CITY OF BELOIT

REPORT TO THE BELOIT LANDMARKS COMMISSION

File Number: COA-2011-30

Location: 703 Park Avenue

Fig.5 mockup of Chapin entrance – Phase 1

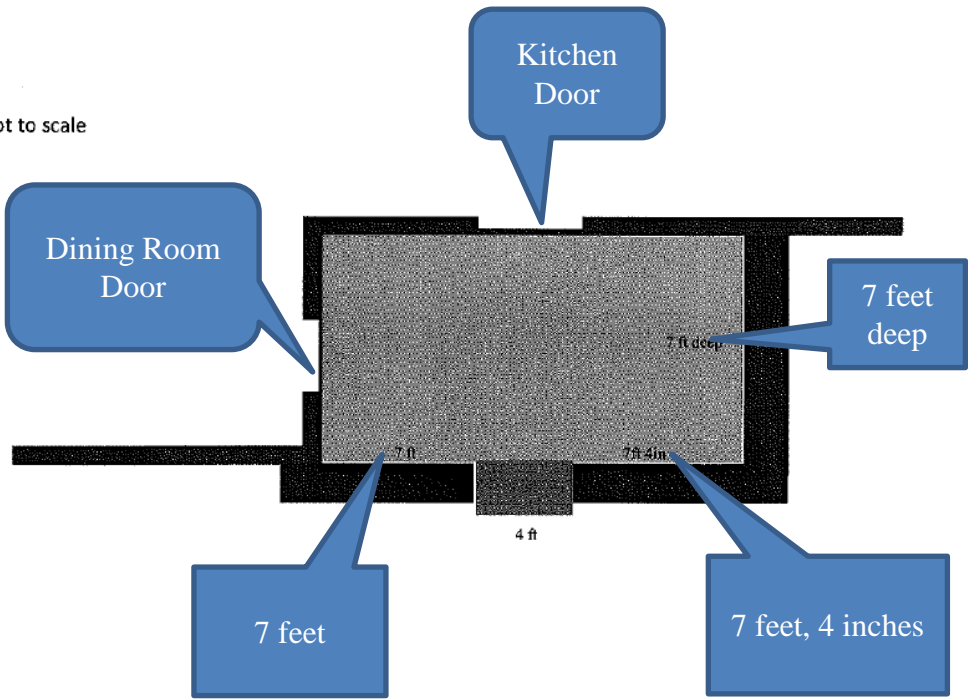
- Removal of the wooden stairway
 - Construction of concrete terrace and stairs
 - The proposed concrete terrace will be 14 feet and 4 inches wide and 7 feet deep. The inset stairway will be 4 feet wide. The height of the proposed concrete terrace will be 2 feet and 6 inches high. The landing of the concrete terrace will be stamped with an imprint of flagstone pavers (see Figure 4 for example of imprint).

- **Phase 2 will occur between the summer and autumn of 2012, and consist of:**
 - Constructing two concrete garden planter boxes at the base of the newly constructed terrace. The intent is to create a cascading look and feel to the terrace desired by the applicant. The planter boxes will be constructed from the same material as the terrace, and will be located on each side of the inset stairway

at the base of the terrace (see Figure 6).

1. The applicant shall construct the terrace that consists of the design and materials specified in the application attachments.
2. The applicant shall install continuous handrails constructed of metal on both open sides of the stair flight pursuant to

The Neighborhood Planning Division recommends approval of a Certificate of Appropriateness to construct a terrace with garden box planters for the property located at 703 Park Avenue, based on the standards and criteria contained in the Historic Preservation Ordinance and subject to the following conditions:
